# Access Compliance Report

## Public Rights-of-Way

### (Curb Ramps)

Intersection ID: 10234	Main Street: MCCARRON_WY	Cross Street: CRANBOURN_CT	Location: NW
ADA ID: 4C928E9A2A4E	Ramp Type: PerpDiag	Initial Pass/Fail: Fail	Overall Compliance: No
		Severity Score: 8.75

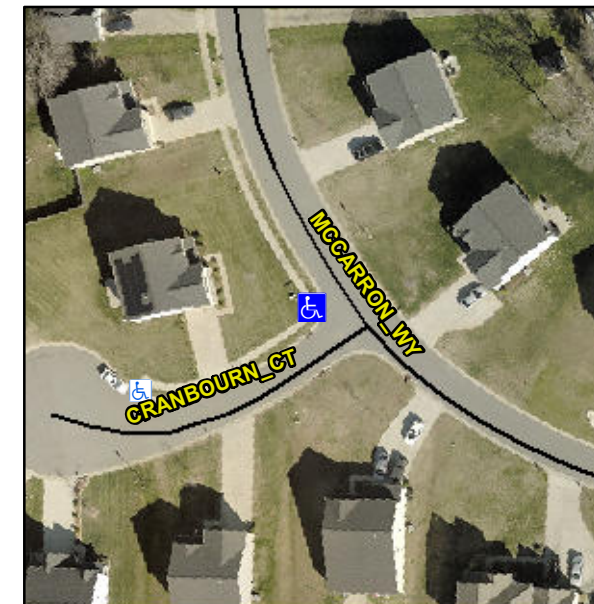
**Not Found, R304.5.1**

Compliance	Description	Data	Compliance	Description	Data
N/A	Ramp Length (in)	47.0	Yes	Ramp Slope (%)	7.1
No	Ramp Width (in)	46.5	Yes	Ramp XSlope (%)	0.8
N/A	Flare Type LT	N/A	N/A	Flare Type RT	N/A
N/A	Flare Slope LT (%)	N/A	N/A	Flare Slope RT (%)	N/A
N/A	Flare Traversable LT?	N/A	N/A	Flare Traversable RT?	N/A
N/A	Landing Length (in)	N/A	N/A	DWS Provided?	N/A
N/A	Landing Width (in)	N/A	N/A	DWS Contrast?	N/A
N/A	Landing Slope (%)	N/A	N/A	DWS Length (in)	N/A
N/A	Landing X Slope (%)	N/A	N/A	DWS Full Width?	N/A
N/A	Landing Curb? (Y/N)	N/A	N/A	DWS Offset (in)	N/A
N/A	Shared Landing?	N/A			
N/A	Gutter Ponding?	N/A	N/A	Gutter Slope (%)	N/A
N/A	Gutter Lip Ht (in)	0.5	N/A	Gutter X Slope (%)	N/A
N/A	Painted X Walk1?	No	N/A	Painted X Walk2?	No
	X Walk 1 Direction	To SE		X Walk 2 Direction	To E
N/A	X Walk 1 Width (in)	N/A	N/A	X Walk 2 Width (in)	N/A
	X Walk 1 Slope (%)	N/A		X Walk 2 Slope (%)	N/A
	X Walk 1 X Slope (%)	N/A		X Walk 2 X Slope (%)	N/A

**Remove & Replace Curb Ramp With Two New Directional Ramps or Equivalent.**
